# Technical Bulletin

Number 190

October 14, 2008

## In-Line Water **SERVICE TIP** Connection Inspection

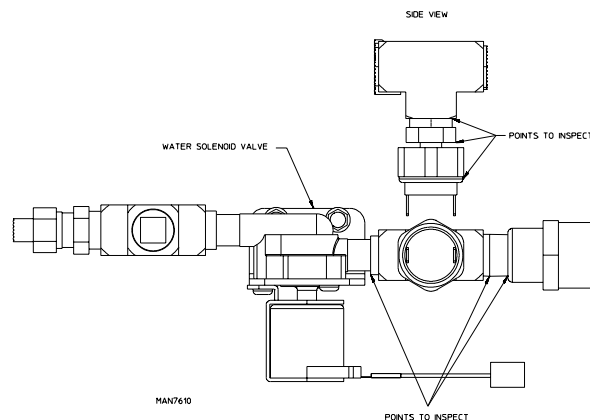
For models manufactured with SAFE or F.S.S., at preliminary installation/start up, and after servicing any SAFE/F.S.S. components, an inspection should be made at the SAFE/F.S.S. dryers water line connections (see illustration) prior to the water solenoid valve to insure that they are no leaks, and that the teflon tape is in place. During the inspection connection points, especially those made of brass, should be inspected for cracks or fractures.

# Mid Line Models with Timer Controls Contactor Change

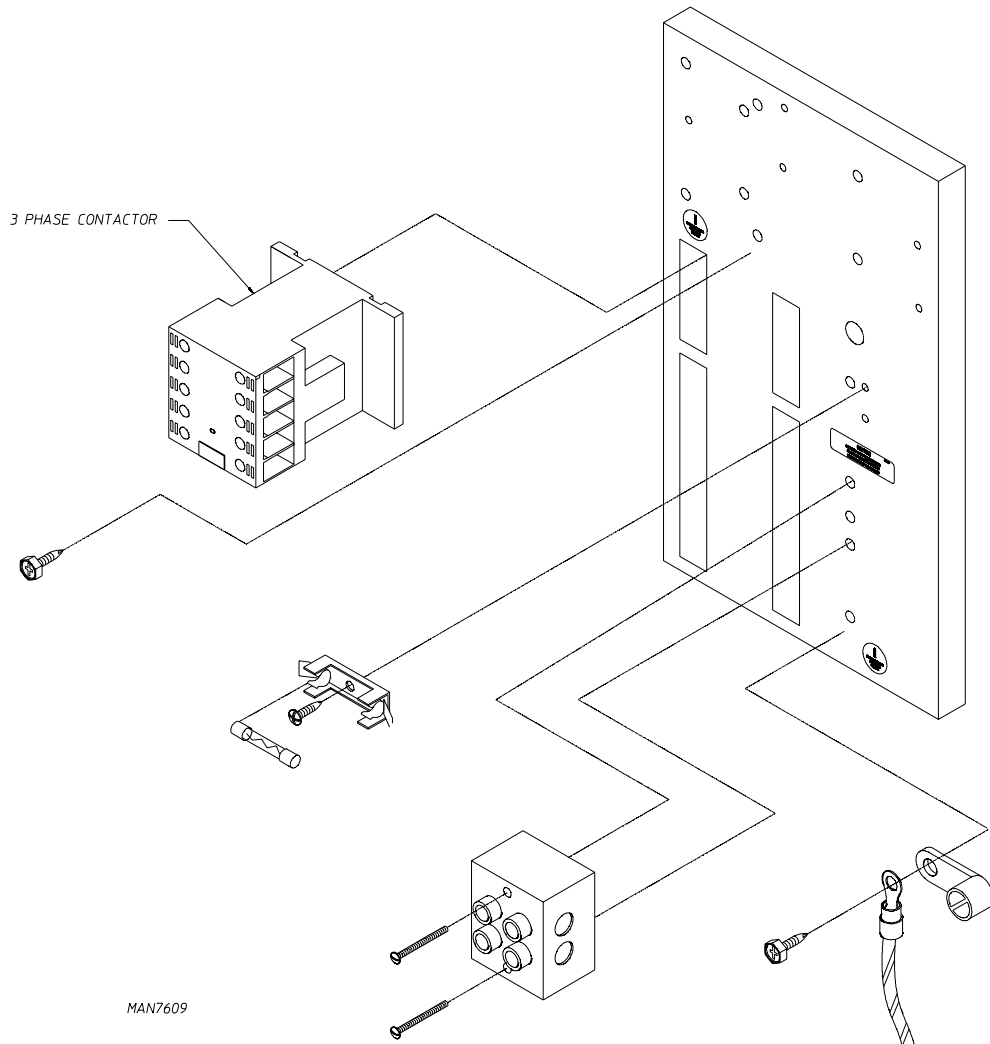
The 3 phase motor contactor used in the mid line models manufactured with timer controls has changed. This change was implemented on September 3, 2008 and includes all related subassemblies sold as parts orders.

Important: The two contactors are not interchangeable without modifications.

Change From			Change To		
Qty.	Part No.	Description	Qty.	Part No.	Description
1	132445	12 AMP 3PH CONTACTOR 24VAC	1	132514	12 AMP 3PH CONT 24V CTRL K-LINE
1	313999	BACKELECT BOX COMPONENT PLATE	1	322812	BACKELECT BOX COMPONENT PLATE
